PLANNING ADVISORY/COMMITTEE OF ADJUSTMENT/ PROPERTY STANDARDS COMMITTEE AGENDA

PLANNING REPORT

SUBJECT: DP2019-06 – 575 KING STREET EAST
CLASS III DEVELOPMENT PERMIT

TITLE:
PROPOSED SITE PLAN

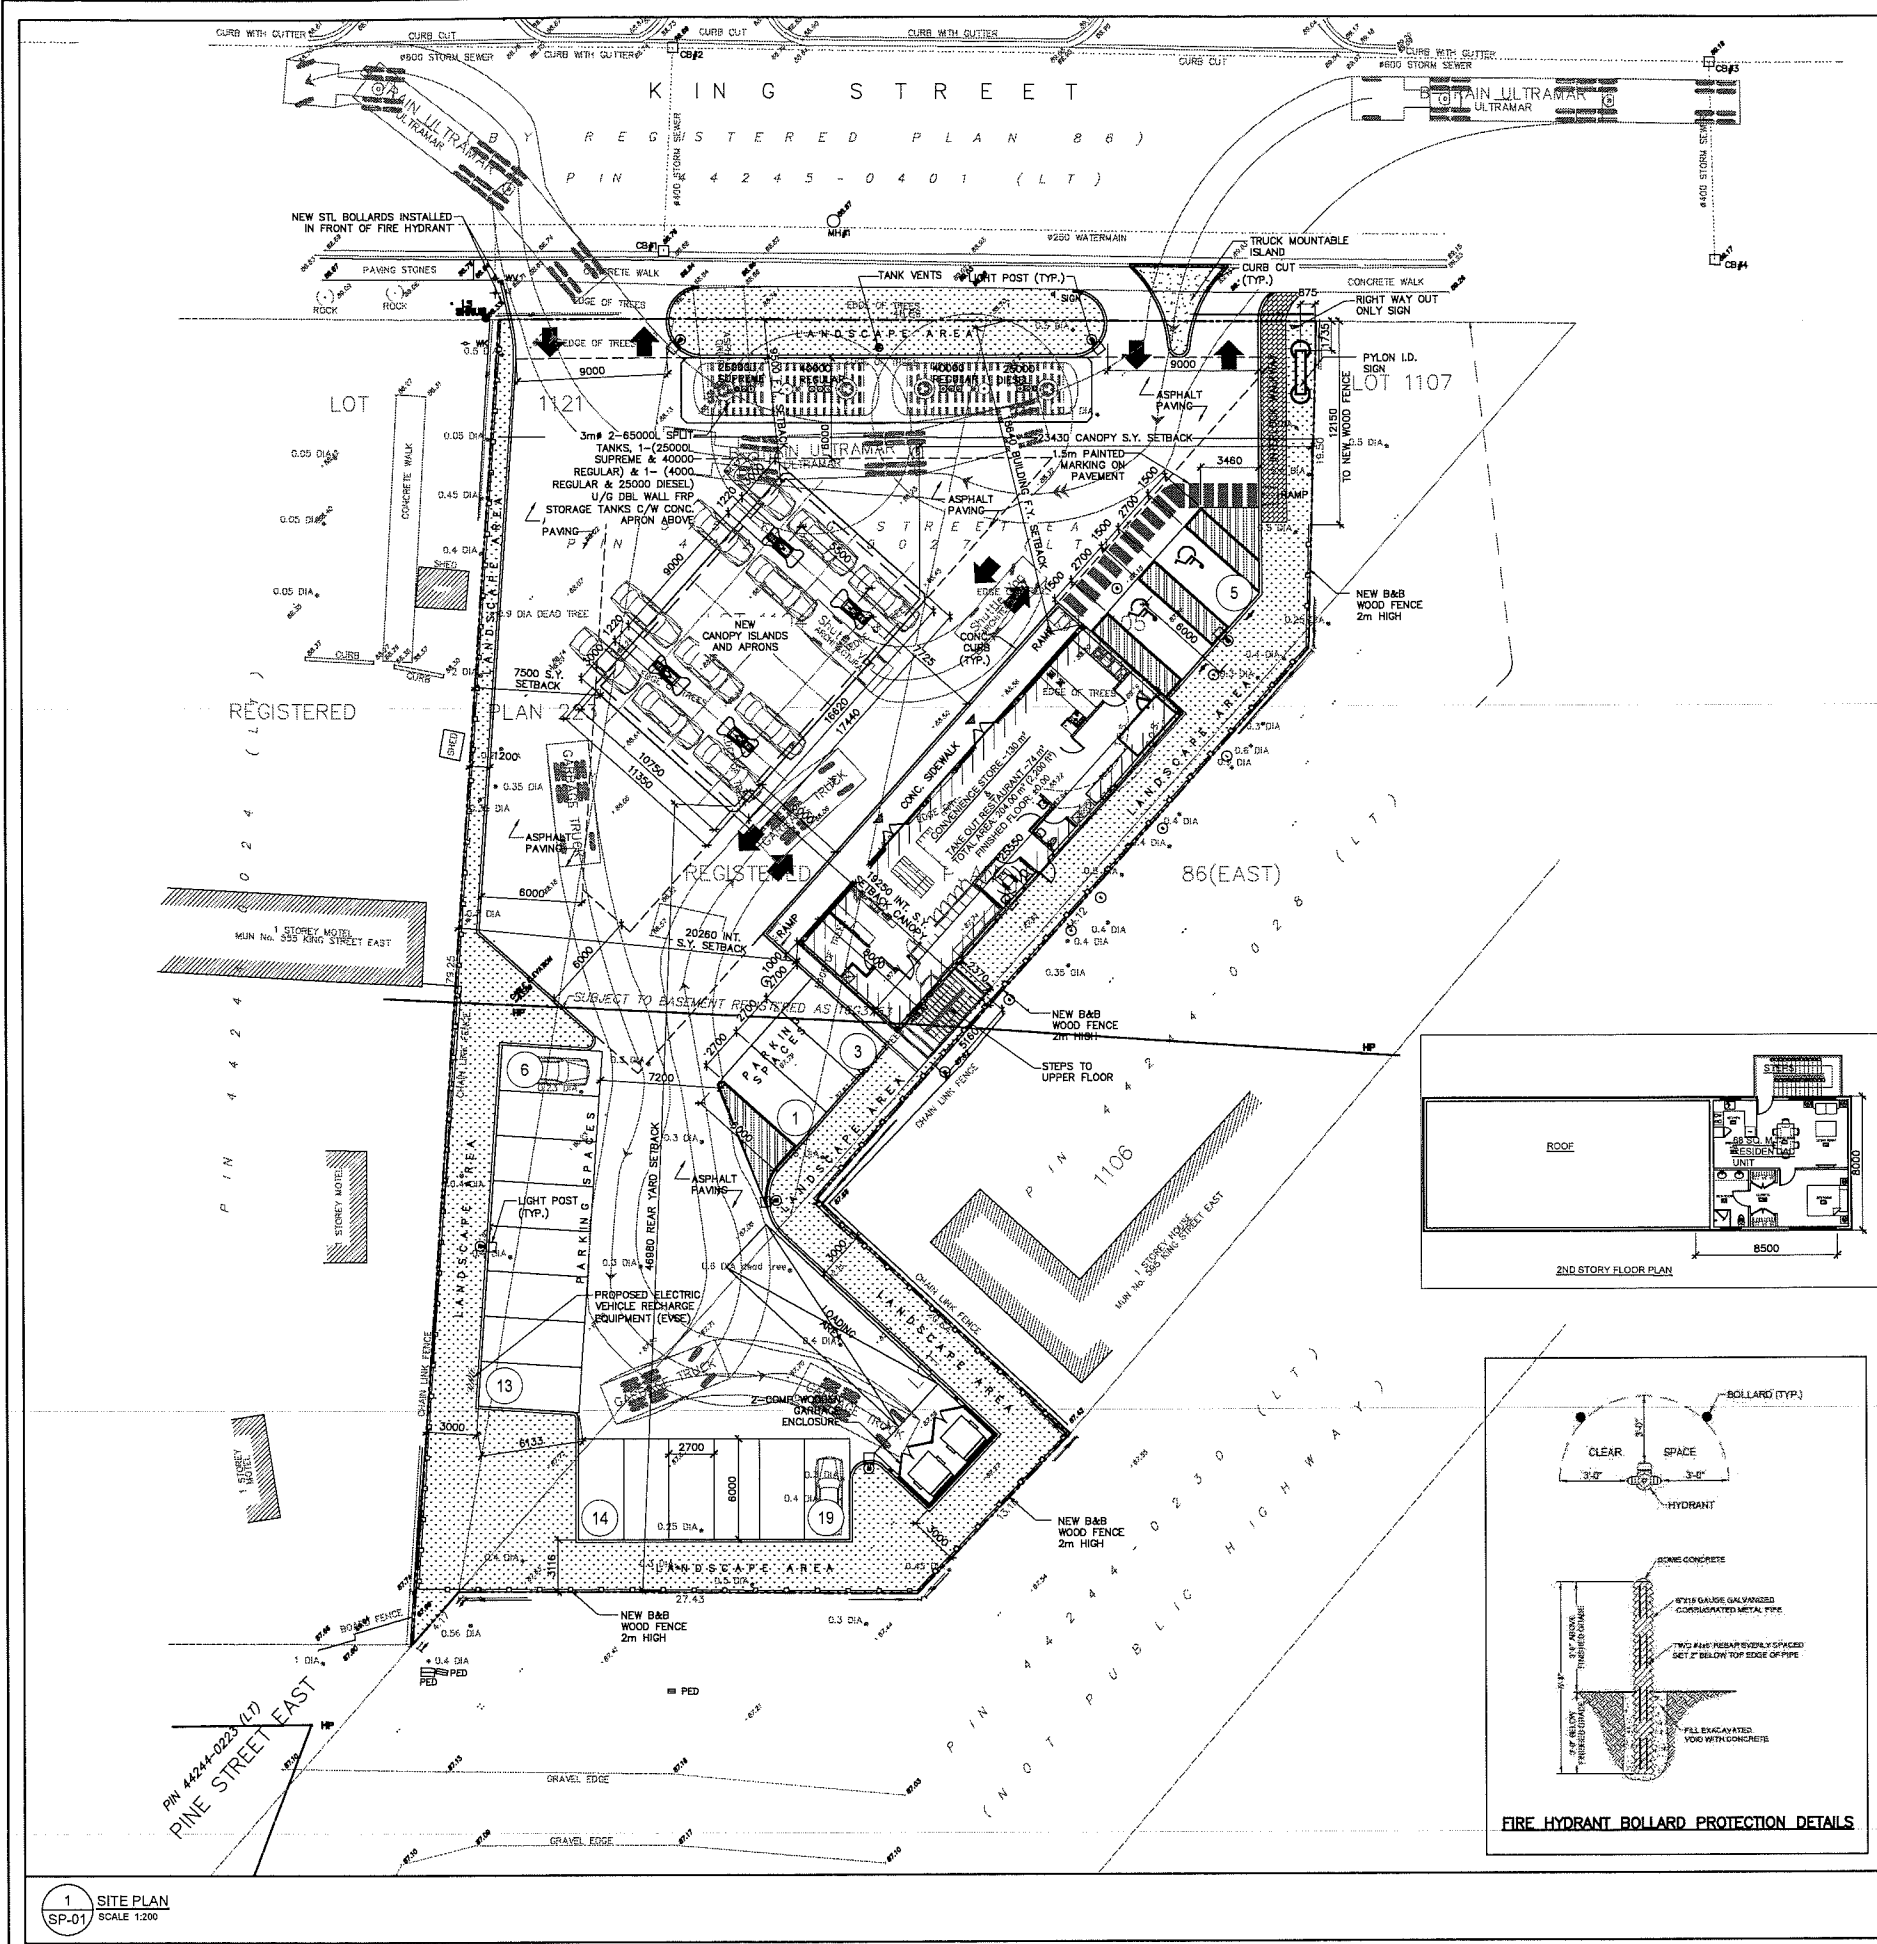
1. **JLRs Initial Comment:** There is no identified location for snow storage, however, Plan L-1 indicates 'Sod and Snow' at the rear of the site. Please clarify sufficient storage location on Site Plan.
GAMA: This note is removed from L-1 as there will be no snow storage on site, all snow will be removed off site.
Response: No further comments.

2. **JLRs Initial Comment:** Please relocate SAN/MH #1 to the property line to allow Town access.
GAMA: The Sanitary Manhole is placed in proximity of the property line at the edge of asphalt area to allow un-obstructed access by city crews and machinery. It can be relocated on top of the island, but we don't see any benefit from it.
Response: The sanitary manhole must be moved to the property line for MISA purposes. If not, the Town will require that an easement be granted in favour of the Town in order to inspect and monitor as necessary.

3. **JLRs Initial Comment:** It appears that truck access is limited to westbound King Street access. Please provide commentary on this aspect. In addition, we notice that an existing hydrant is located very close to the west entrance and the necessary truck turning radii. We suggest that the developer coordinate with Town of Gananoque Public Works regarding the need to potentially offset or relocate the hydrant.
GAMA: The truck access is limited to westbound King Street access as the off-loading of fuel is on the right hand side of the truck and the closest exit off the major highway (Hwy 401) is east of this location. In terms of the fire hydrant location, this has been noted being away a meter from the curb line. We suggest if further protection is required, a couple of bollards can be installed in front of the hydrant rather than relocating or offsetting this hydrant's location for concerns of the truck turning radii. Please see revised SP-01.

4. **JLRs Initial Comment:** Planning staff should take note that stairs (unknown material type) are proposed within the east yard setback. East yard setback along rear of main building is also not noted. Proponent to provide additional information on stairs and clarify setback distance.
GAMA: The stairs will be constructed out of pressure treated wood and is allow for the access of the second floor unit. East yard setback along the rear of main building is noted as 3.0m and dimensioned on SP-01. Full details will be submitted during building permit application for further review and approval.
Response: Town Planning staff have no further comment.

5. **JLRs Initial Comment:** Please clarify line painting around barrier free parking spaces, provide signage and note accessible construction requirements of ramps on walkways and entrances. (Drawing MS-1 was not included in the re-submission)
GAMA: Noted. Please see attached MS-1 for required information on ramps and parking spaces.
Response: The ramp details are noted. However, barrier free parking buffers on SP-01 do not match typical design as noted on MS-1L. SP-01 is considered acceptable please provide matching designs. Additionally, please use a tactile walking surface indicator (TWSI) instead of the grooved concrete ramp. TWSI are preferred design within AODA guidelines.

6. **JLRs Initial Comment:** Please clarify the length (extents) of the proposed 2m wood fence on the east property line and the proposed chain link fence on the west property line. It is difficult to determine on the drawing.
GAMA: Please note the new 2.0m high wood fence surrounds the property and ends at the North property line on the west side. The chain-link fence that you have noted is part of the neighbouring property. The start of the fence on the east property has been dimensioned on SP-1.
Response: Thank you for the clarification, no further comment.

7. **JLRs Initial Comment:** Text on building is illegible. Please revise.
GAMA: Noted and enlarged.
Response: Thank you for the clarification, no further comment.

18. **JLRs Initial Comment:** Garbage truck access to enclosure requires truck to back up a fair distance in order to exit the site. Please confirm truck turning requirements on site for this vehicle.

Response: The Town's position is that if any damage due to trucks entering and exiting the premise exists, that all costs associated of fixing and/or relocating the existing hydrant for extra space will be borne by the owner of the site.

GAMA: Please see revised drawing SP-1 to show Garbage Truck movement in this area.

Response: Thank you for the clarification, no further comment.
